LAWRENCE HISTORIC RESOURCES COMMISSION
AGENDA FOR **APRIL 18, 2019**
CITY HALL, 6 E 6TH STREET
6:00 PM

**LAWRENCE HISTORIC RESOURCES
ADMINISTRATIVE REVIEW
STAFF REPORT**

TO: Historic Resources Commission
FROM: Kyle Kobe, Planner I
DATE: April 18, 2019
RE: Item No. 8: DR-19-00092 1009 New Jersey Street deferred from March 21, 2019 Agenda

① WEST ELEVATION
1/4" = 1'-0"

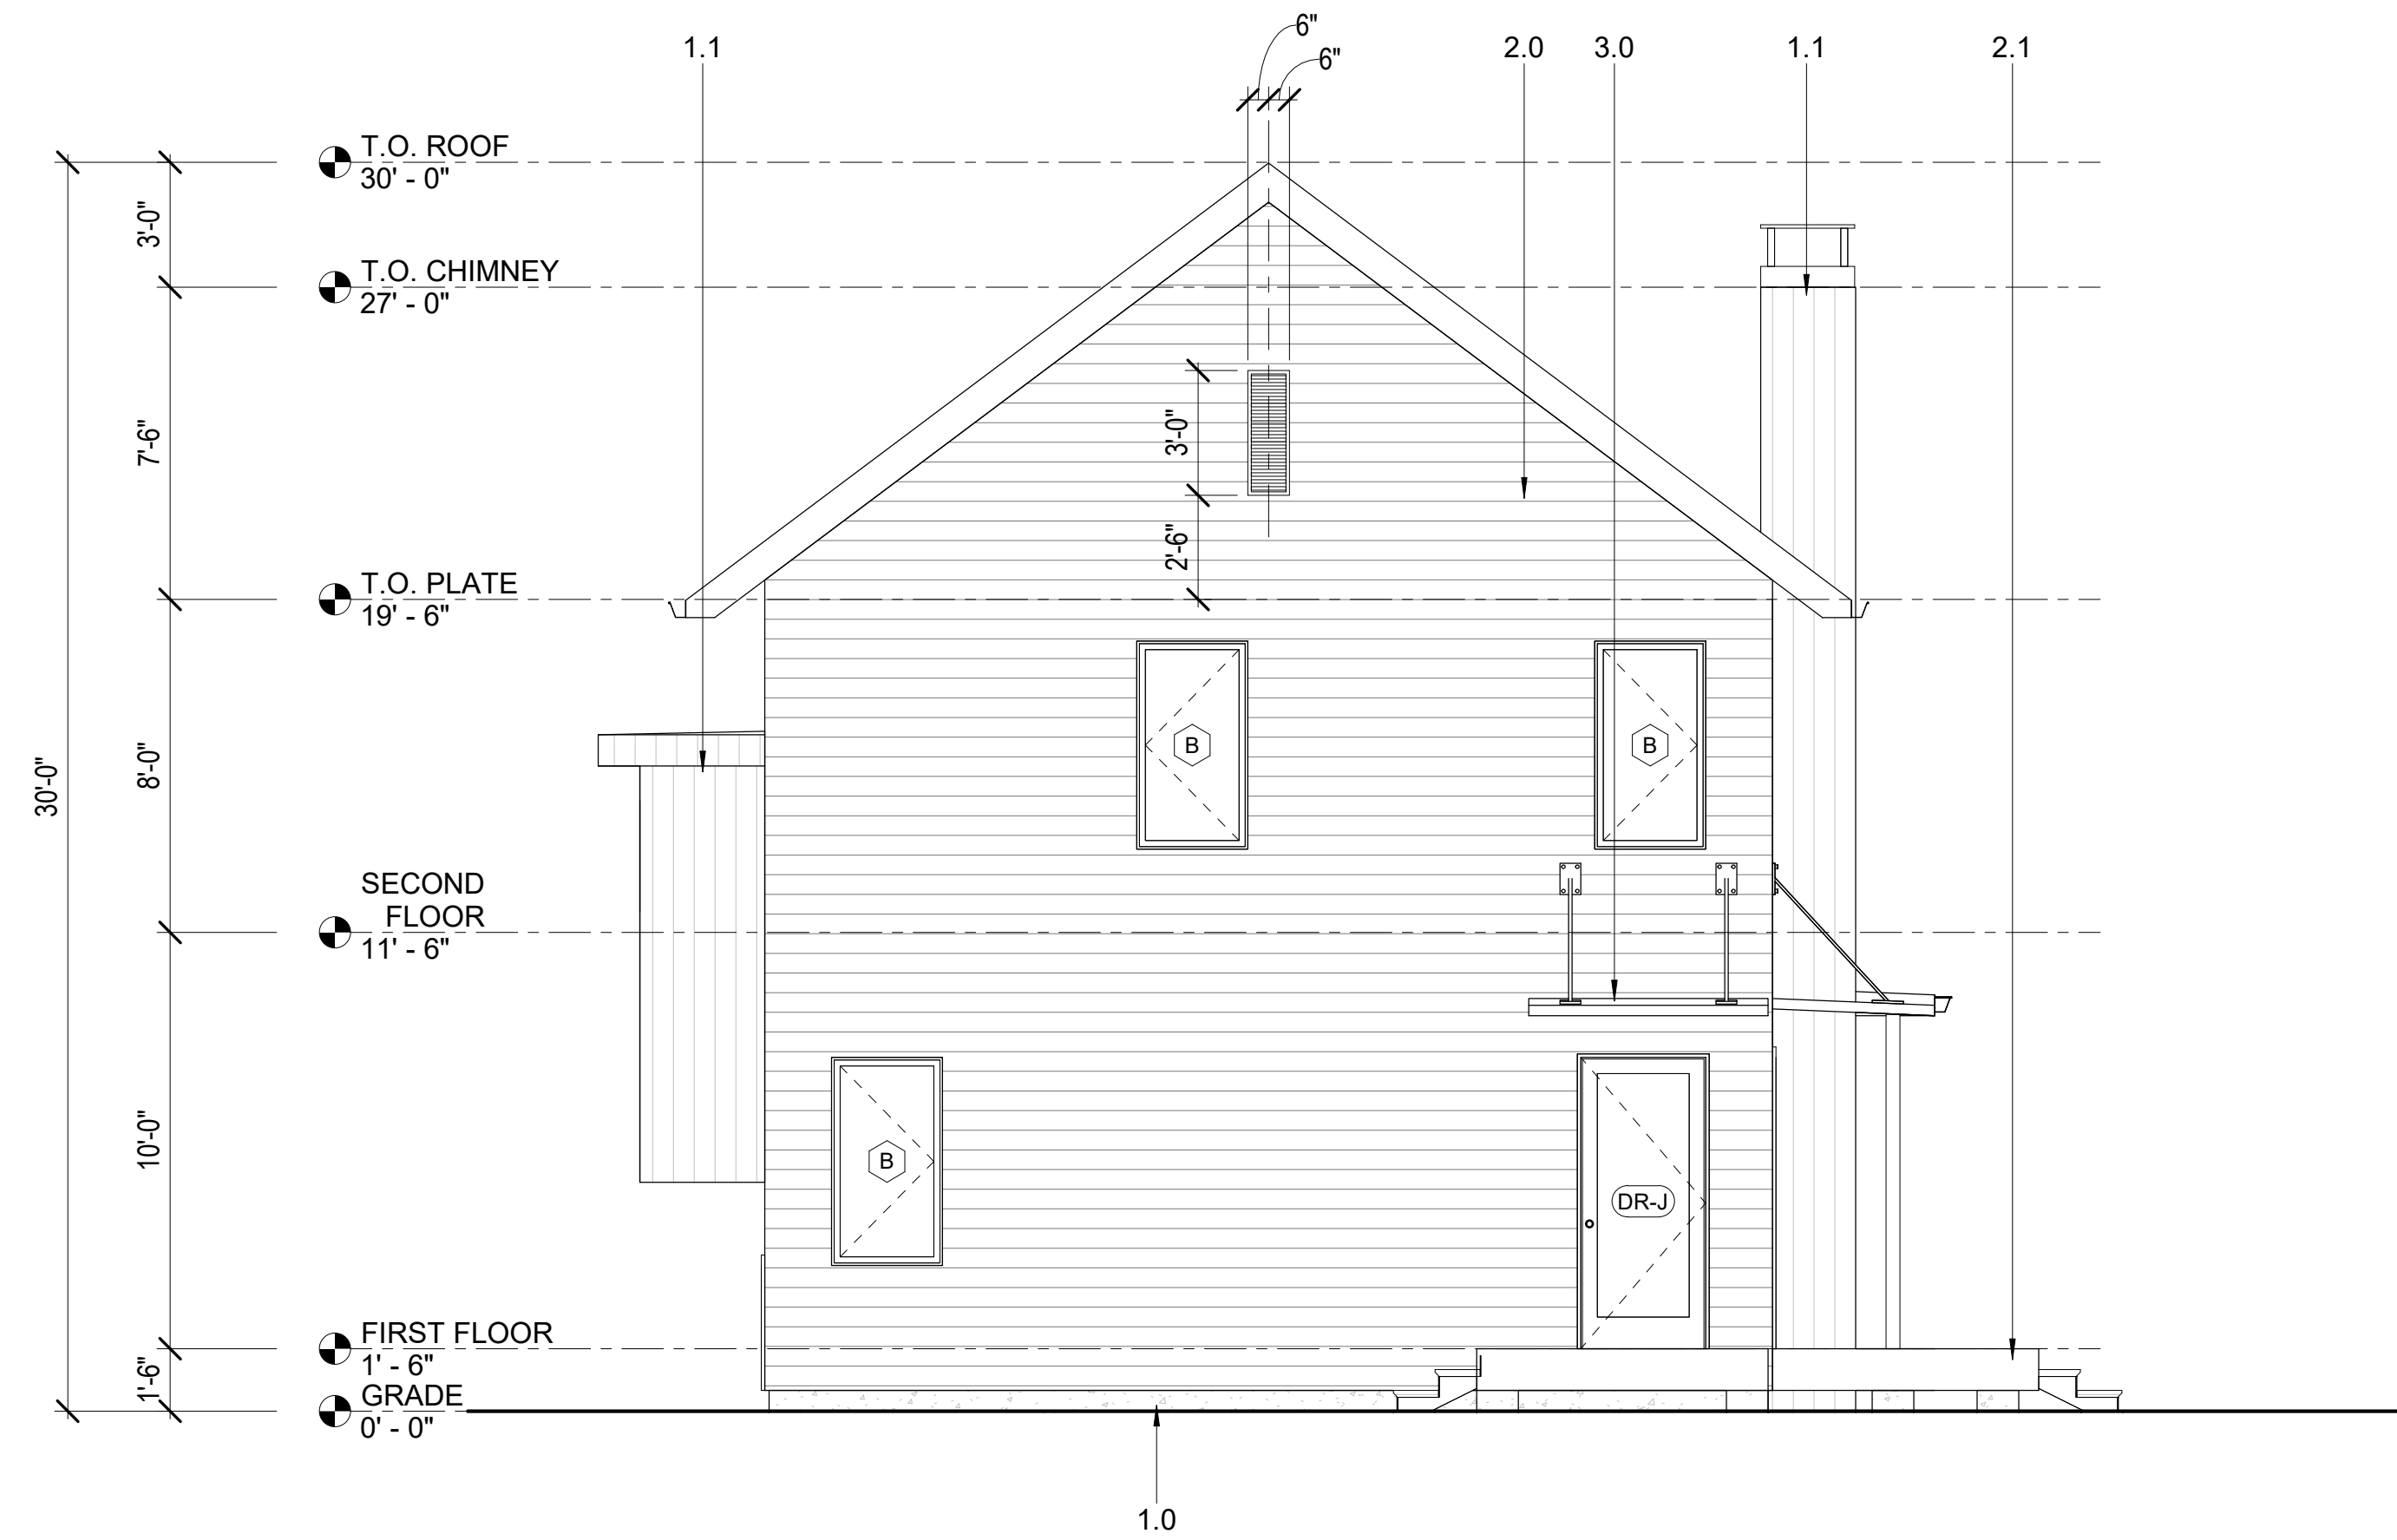
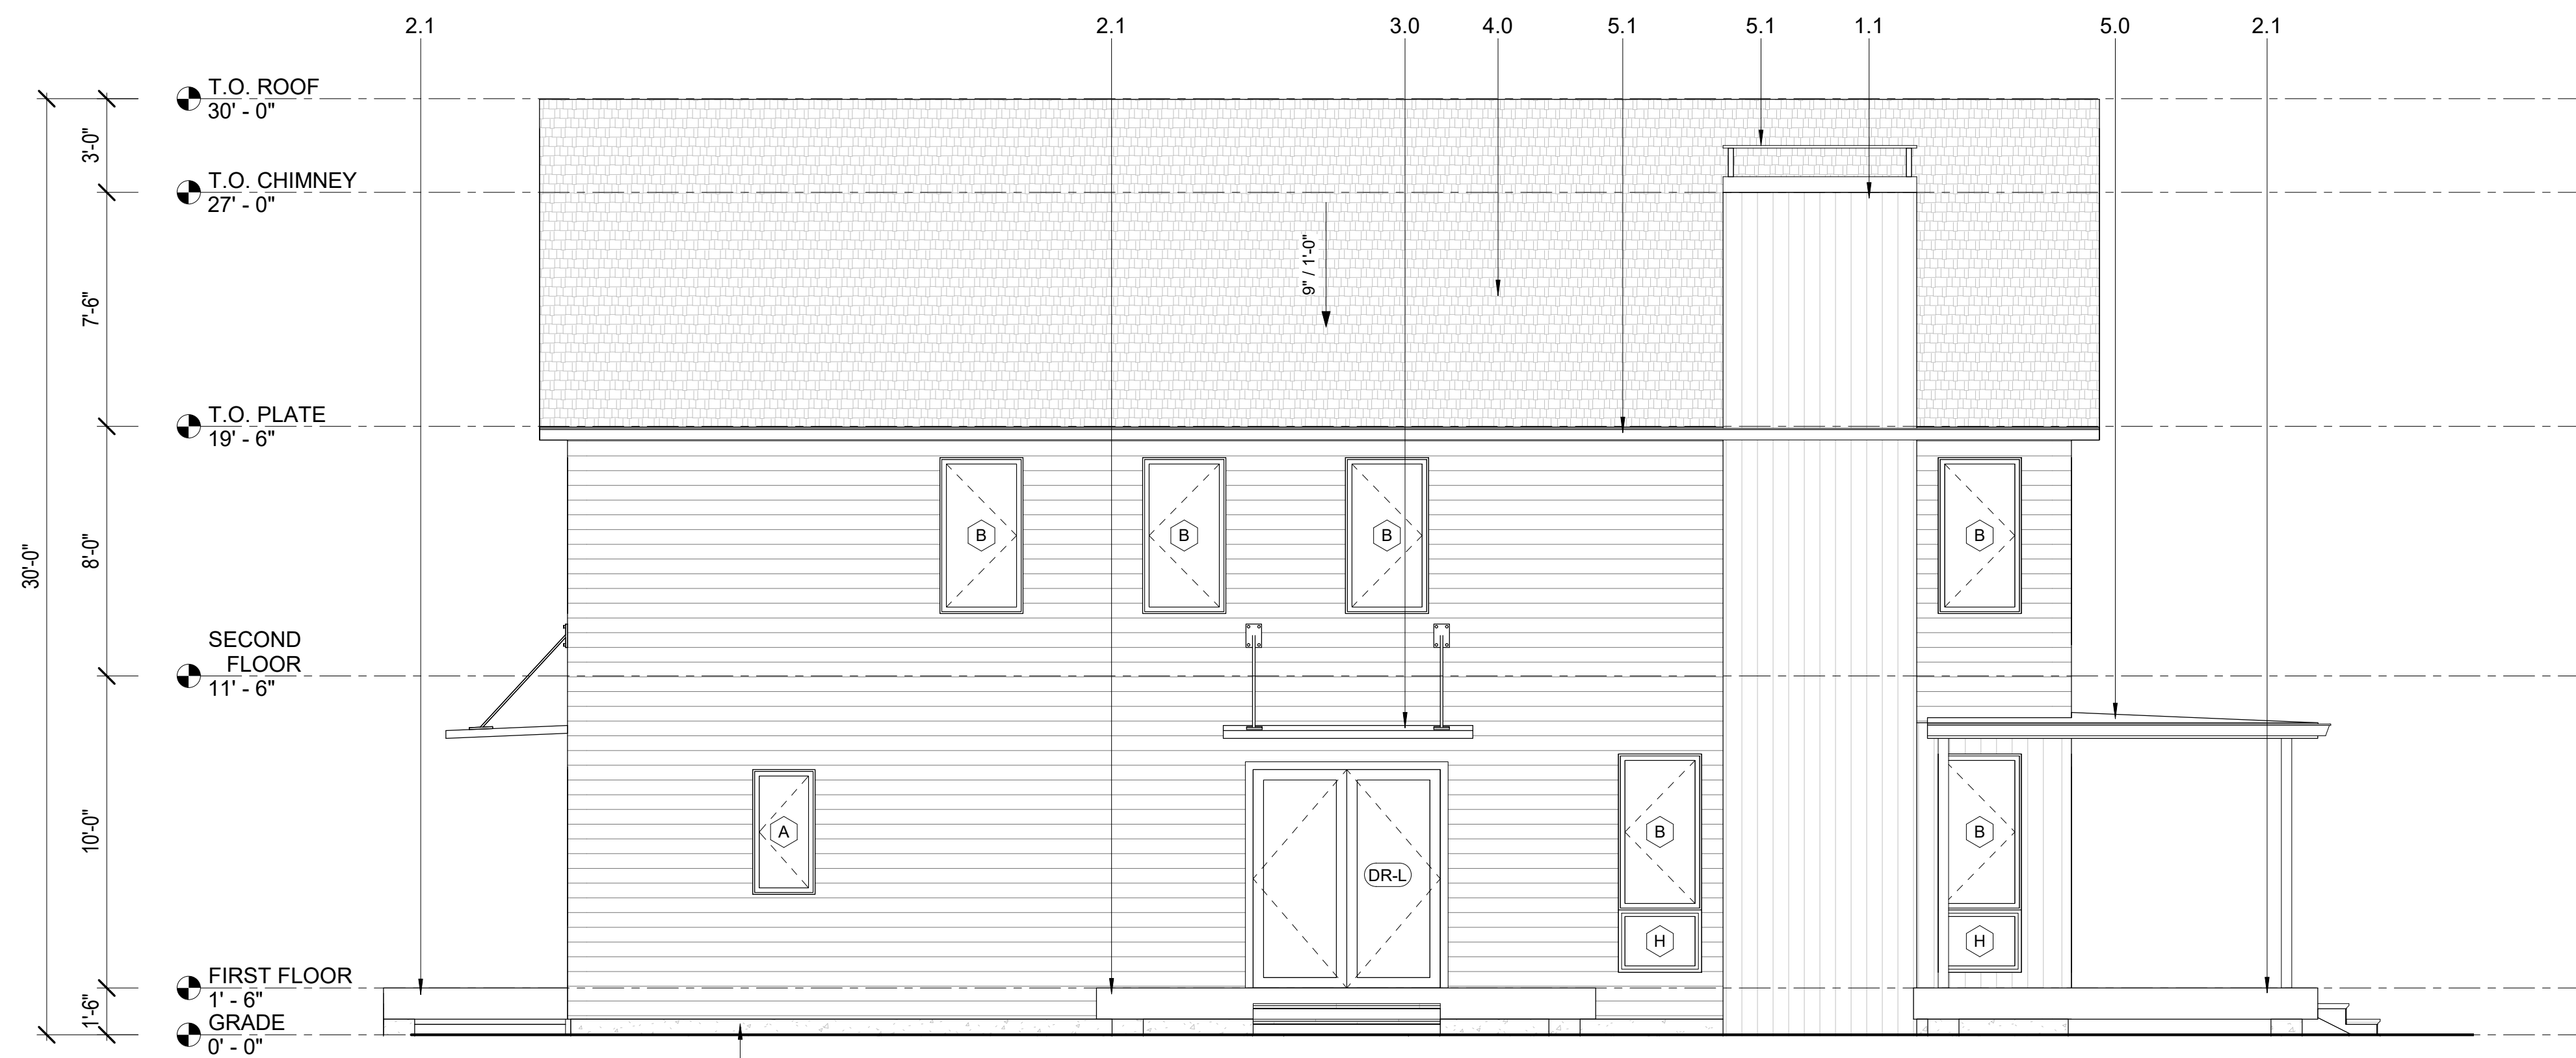
The ARC requested the applicant submit revised drawings showing the agreed upon changes. The applicant submitted revised drawings on April 9, 2019. The drawings showed the use of 4 inch by 4 inch columns. The applicant also requested to use vinyl windows due to cost.

Staff recommends the commission review the revised plans attached to this memo and make a final determination on the column size and the use of vinyl windows in their deliberation on the project. If the commission votes to approve the project, staff recommends the commission direct staff to review any subsequent minor alterations to

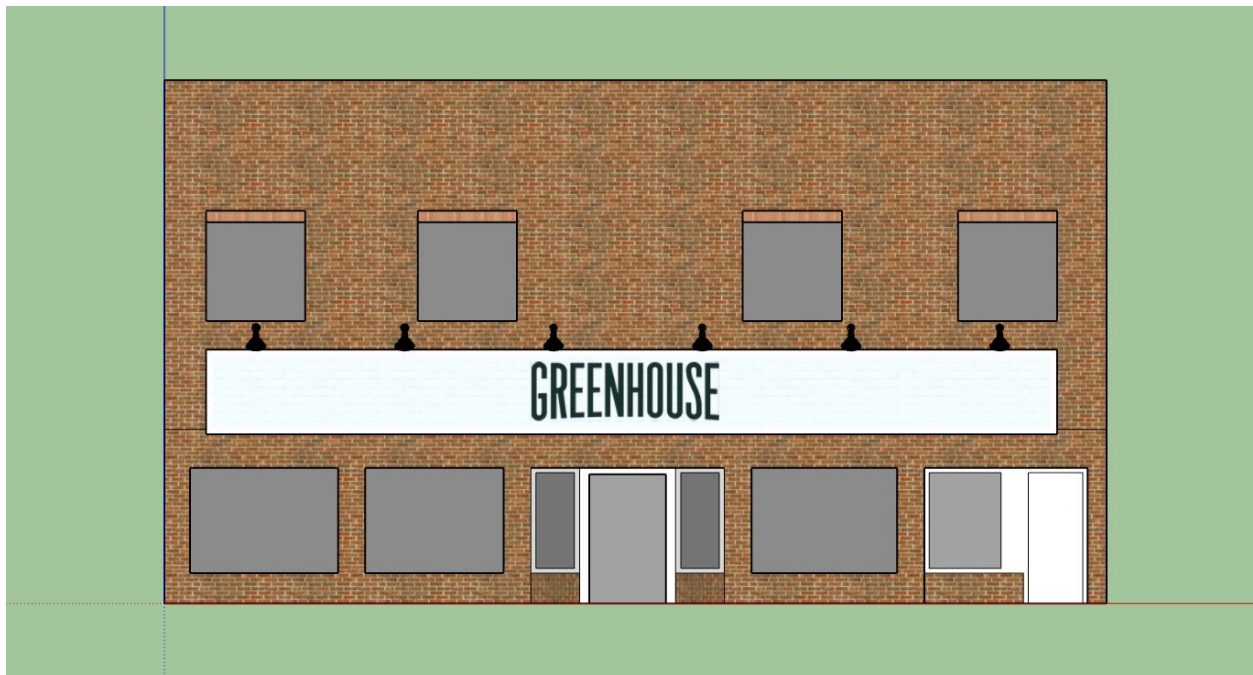
The proposed project offers three options. Option one includes removing the decorative tile and brick detail. The removal of the existing decorative panel in the center of the façade alters the proportion and balance of the existing building. Unpainted wood is not appropriate for building facades on commercial structures in the district. The size of the wall sign is too large to be pedestrian oriented. Unpainted masonry surfaces should never be painted. Not only does the paint remove the masonry appearance, but it is also harmful to the longevity of the building. Brick, even a modern brick veneer is designed to allow moisture to move through the brick. Paint coats the brick in such a way that the brick cannot allow the moisture to move through the brick. This results in the delamination of the brick and spalling. Proposal one does not meet the intent of the Design Guidelines because of the removal of the existing tile and brick area, the proposed wood material to replace the area, and the painting of the brick on the ground level.

Option two is similar to option one in that it will remove the existing tile and brick decorative feature and paint the ground level of the structure. New white tile will replace the existing tile but will extend to the edge of the façade leaving no brick accent for the area that creates containment for the panel. The removal of the brick on the four sides of the tile changes the overall scale of the façade. Proposal two does not meet the intent of the Design Guidelines as it continues to use a material that is not appropriate for the façade, removes the enframing of the central panel, and paints the brick on the ground floor.

Proposal three is similar to option one and two as it proposes to remove the existing tile and brick decorative feature and paint the ground level of the structure. A new awning will span the width

The structure located at 1012 Massachusetts Street is challenging for alterations to the existing façade. The existing tile with brick panel separates the lower floor from the upper floor in an appropriate location to give the building the appropriate scale. Lowering a panel on the façade will offset the proportions of the façade. If this area of the façade is altered, it will be important to determine how the section of the façade that will be removed to lower the panel will be treated. This change may have unintended consequences for the overall visual quality of the façade as this area may read as a patch.
